**Road Safety Audit**  
**Stage 2**  
**for**  
**Access Proposals**  
**at**  
**Kilmurray Concrete**  
**R400, Derryarkin, Rhode, Co Offaly**

**Reference:** RSM/MOB/140921/KILMURRAY RSA 2

<b>Client</b>	Kilmurray Concrete
<b>Project Title</b>	Access Proposals at Kilmurray Concrete, Derrryarkin, Co Offaly
<b>Document Title</b>	Stage 2 Road Safety Audit
<b>Document Ref.</b>	RSM/MOB/140921/KILMURRAY RSA 2
<b>Status</b>	Final

**Figure 2: Proposed Site Access Junction**

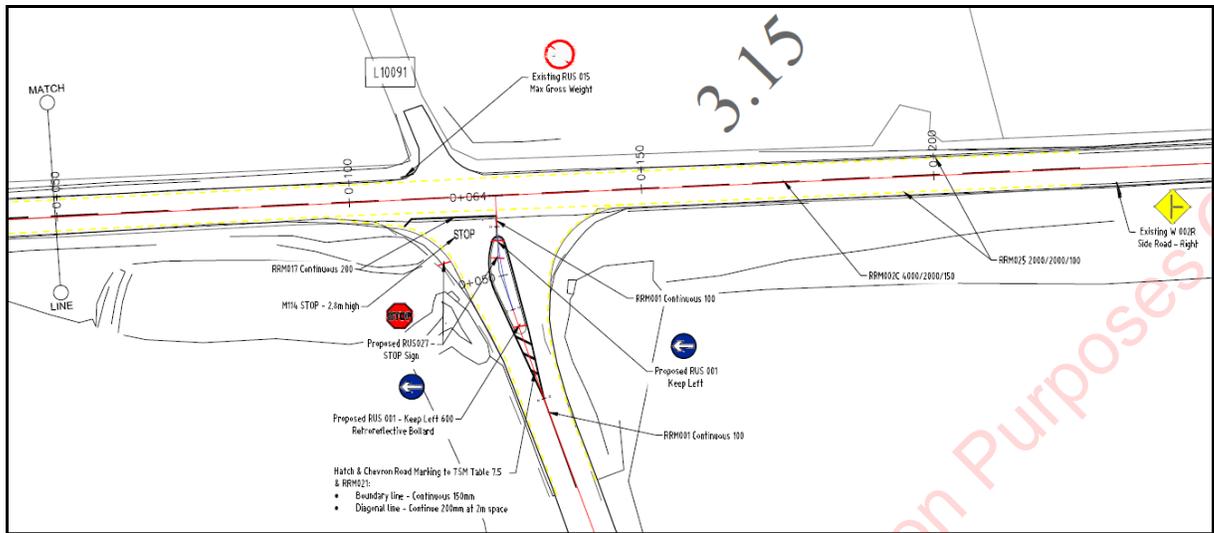
2.1.1 The designers have not advised of any departures from standard. It was noted that the proposals for the minor road access into the Kilmurray Quarry site include provision of a channelising island, and the junction is configured as a crossroads, which is a departure from standard for a rural single carriageway road. The proposed design does not include any amendments to the minor road on the northern side of the junction, where substandard conditions were noted, which includes a narrow cross section which is insufficiently wide for safe two-way use, with visibility splay obstructions to the left and right. The existing substandard layout will increase the overall level of risk at this intersection.

**Figure 3: Collision Plot for Road Network surrounding site**

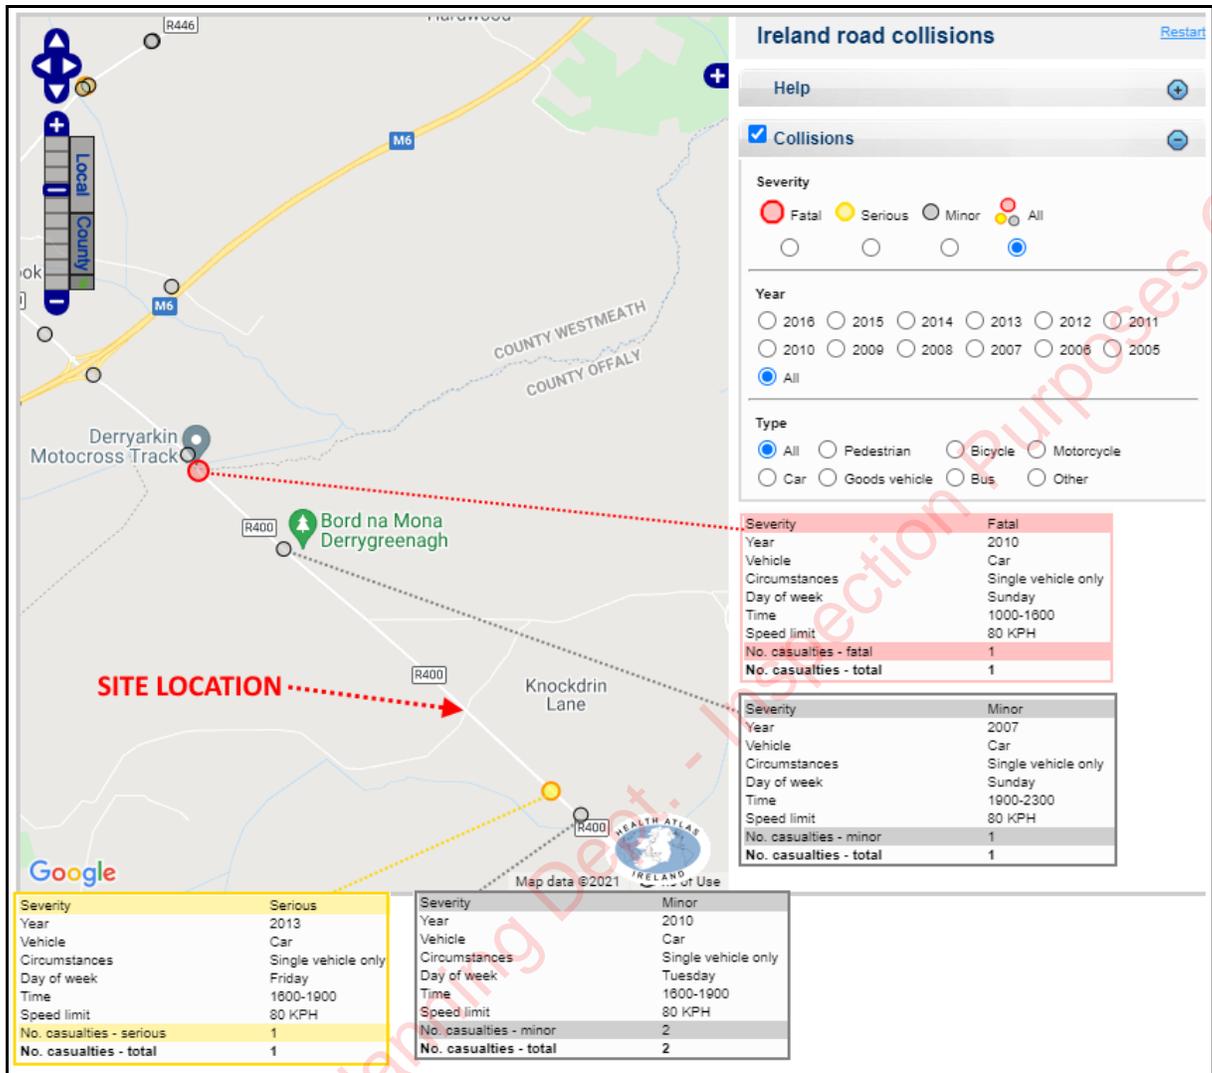
2.1.2 No information was provided on any existing collision statistics in the vicinity of the site. A review of the Road Safety Authority online collision database indicates that there were no collisions recorded in the immediate vicinity of the access junction to the Kilmurray Quarry on the R400 between 2005 and 2016 inclusive. There were a number of collisions recorded further north and south on the link, including one serious collision and one collision resulting in a fatality, as shown in Figure 3. All of these collisions were single vehicle collisions, which can be indicative of inappropriate speeds and loss of control.

It should be noted that the RSA database is not a comprehensive record of collisions, and should be reviewed in conjunction with the Local Authority / Gardaí records for the site.

**Figure 4: New kerbs and shallow crossfall on cross section south of channelising Island**

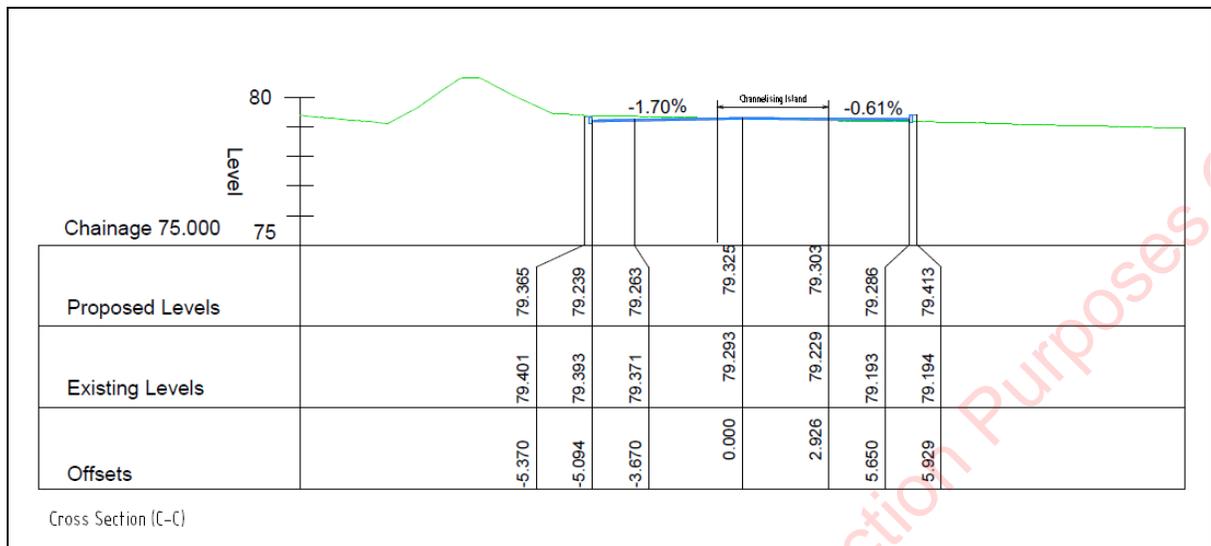
There was no information provided relating to proposed drainage at the reconfigured access junction. The design proposals will involve kerb design and provision of a new channelising island at the access to the Quarry, which will impact on existing drainage on the southern side of the proposed junction. A relatively shallow crossfall is proposed on the entry to the minor arm, as shown in the cross section in figure 4, increasing the risk of ponding and standing water at this location. New kerbs will prevent current runoff into verges, and the provision for new drainage is not clear. Insufficient drainage can lead to an increase in the risk of conflict for all road users, including skidding and loss of control type collisions particularly during wet and icy conditions.

1. The access junction will need to be adequately drained to prevent build-up of surface water, with drainage to be designed to ensure no run-off onto the regional road adjacent, and with the junction to be reprofiled as necessary to achieve suitable crossfall to aid positive drainage adjacent to new kerb line.
2. Drainage proposals should be clarified in advance of construction, with any new gullies and drainage channels to be located outside the desire line for two-wheeled vehicles, and all finished gully levels to be flush with the surrounding carriageway.

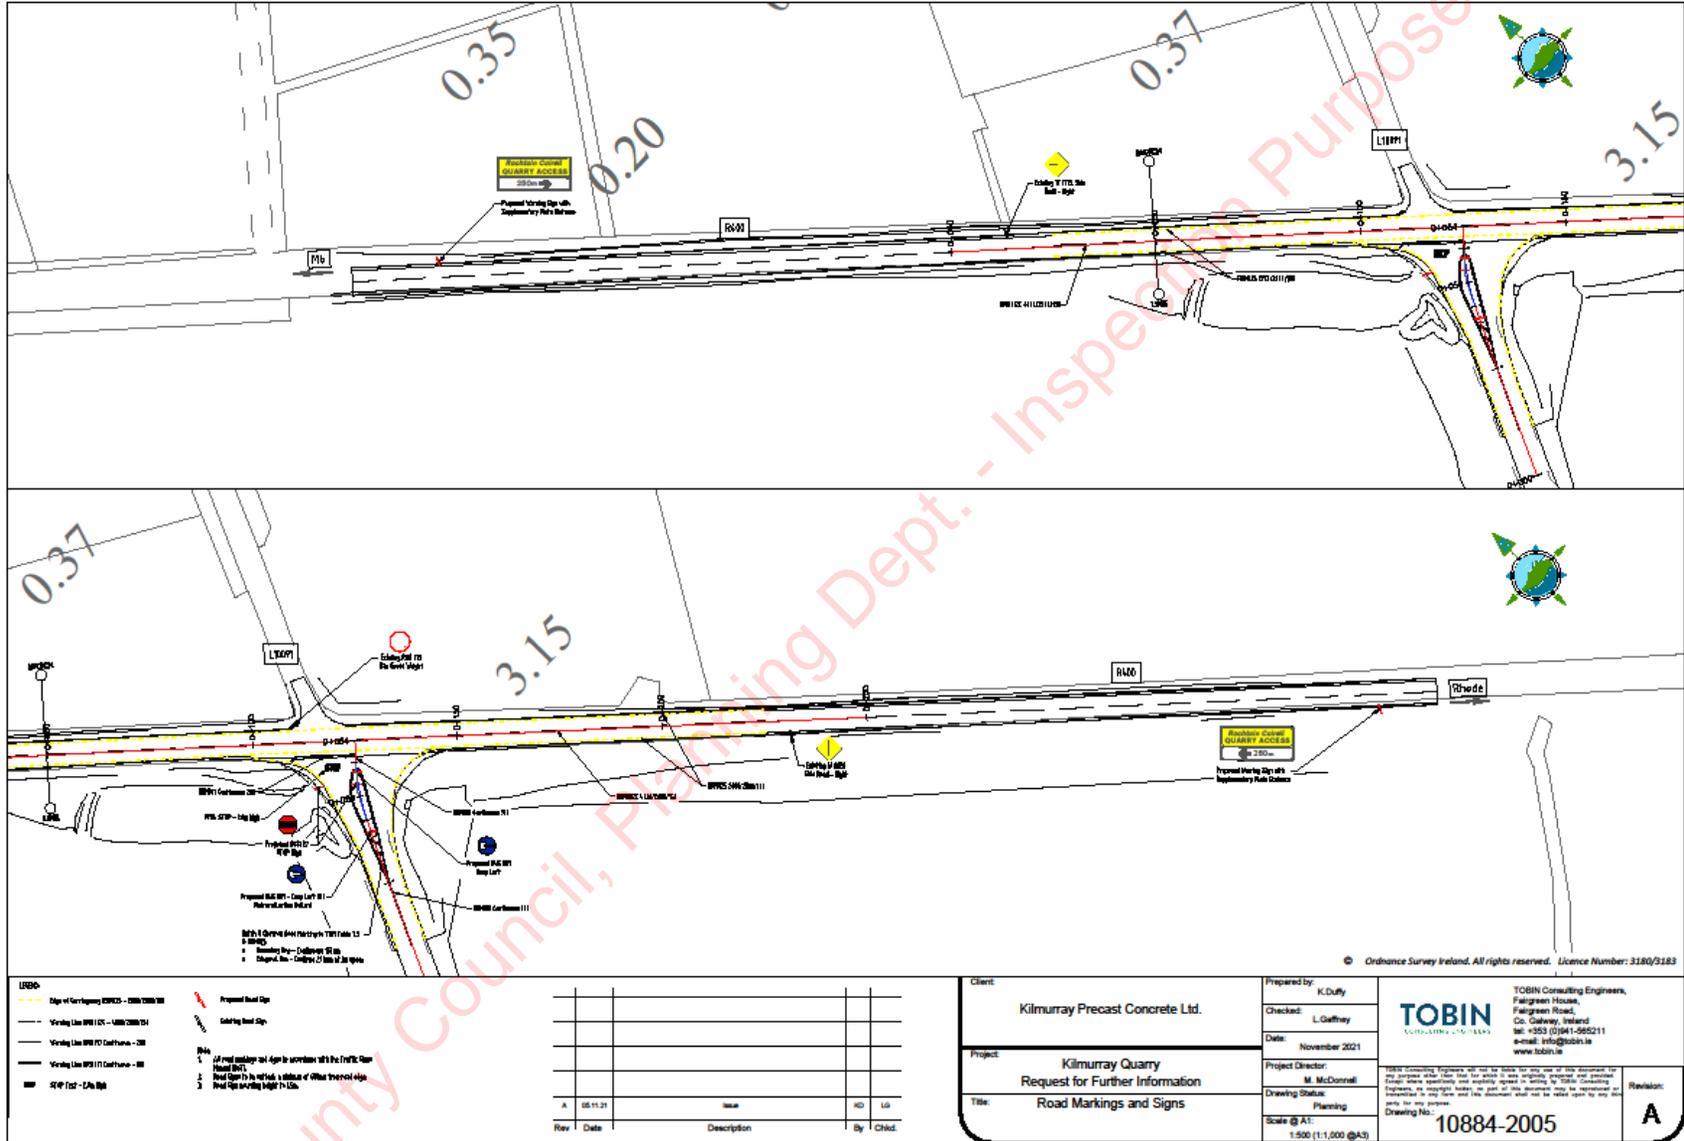
There was no signing and lining schedule produced to accompany the preliminary design, although notes to the relevant sign parameters with reference to the Traffic Signs Manual have been included on the design plan. There were no road markings on the approaches to the site at present, however provision has been made for centreline and edge of carriageway markings on the proposed layout.

- 2.4.2.1 The proposed design does not include provision for Junction definition posts (JDPs). The proposed kerb buildouts and island will present new hazards which may not be clearly visible during hours of darkness.
- 2.4.2.2 Longitudinal approach markings at the proposed channelisation island appear to be located close to the hazard, increasing the risk that the hazard may be struck by passing and turning vehicles.
- 2.4.2.3 Proposed signs appear to be located too close to the carriageway edges, particularly on the proposed channelisation island, presenting an increased risk of being struck by passing and turning vehicles. There is evidence of existing warning signage at the site being struck, as shown in the photo in figure 17. Mounting heights of some of the existing signage is also low, which can present a hazard to two-wheeled vehicles.

1. A review of all existing and proposed signs and road marking requirements is recommended in advance of construction to take into account issues raised in this Stage 1/2 RSA report, with a signing and lining schedule to be produced to include sign sizes and mounting heights.

2. All signs should be placed in a location which is clearly visible to motorists and clear of vegetation, with signs to be passively safe, and/or provided with pole diameters less than 89mm.

3. All signs should be sufficiently setback from the carriageway edges to avoid being struck by passing/turning vehicles, typically a minimum 600mm offset is required between the edge of sign face and the edge of carriageway.

4. All signs and lines to have high reflectivity specification to ensure visibility during the hours of darkness, and provision should be made for road studs where necessary to further enhance delineation during the hours of darkness.

5. A JDP should be provided on each side of the junction at a prominent location to highlight the presence of the junction and enhance conspicuity of all associated hazards during the hours of darkness.

6. Longitudinal approach markings to the proposed channelising island on the southern arm of the junction should be provided at an offset of 150mm from the kerb edges.

7. Detailed design should include for site clearance to include for removal of any redundant signs and road markings, with suitable tie ins to existing markings to the north and south on the R400.

8. The Stop line edge nearest the major road should be a minimum 0.6m offset from the channel line on the paved surface.
9. Centreline markings proposals should be reviewed to include provision for measures to discourage overtaking manoeuvres on the approaches to the crossroads junction.

Problem 2.4.2 Recommendation 3	Yes	Yes	<p>Refer to Drawing No. 10884-2005 Notes in the Legend, which indicate sign setback of 600mm.</p>	
Problem 2.4.2 Recommendation 4	Yes	Yes	<p>Refer to Drawing No. 10884-2005 Notes in the Legend, which indicate sign and line reflectivity in accordance with TII Specification Series 1200.</p>

Road Studs are proposed in accordance with the TSM, refer to Drawing No. 10884-2005.
Problem 2.4.2 Recommendation 5	Yes	Yes	Junction Definition Posts are proposed on the updated Drawing No. 10884-2005 to TII SCD-01204. To the private access road only as the L10091 is outside the scope of the works.
Problem 2.4.2 Recommendation 6	Yes	Yes	On Drawing No. 10884-2005 the road marking have been offset a minimum of 150mm.
Problem 2.4.2 Recommendation 7	Yes	Yes	
Problem 2.4.2 Recommendation 8	Yes	Yes	On Drawing No. 10884-2005 the road marking have been offset a 600mm in accordance with the TSM.
Problem 2.4.2 Recommendation 9	No	No	Refer to Alternative Response to Problem 2.1.7 Recommendation 4.
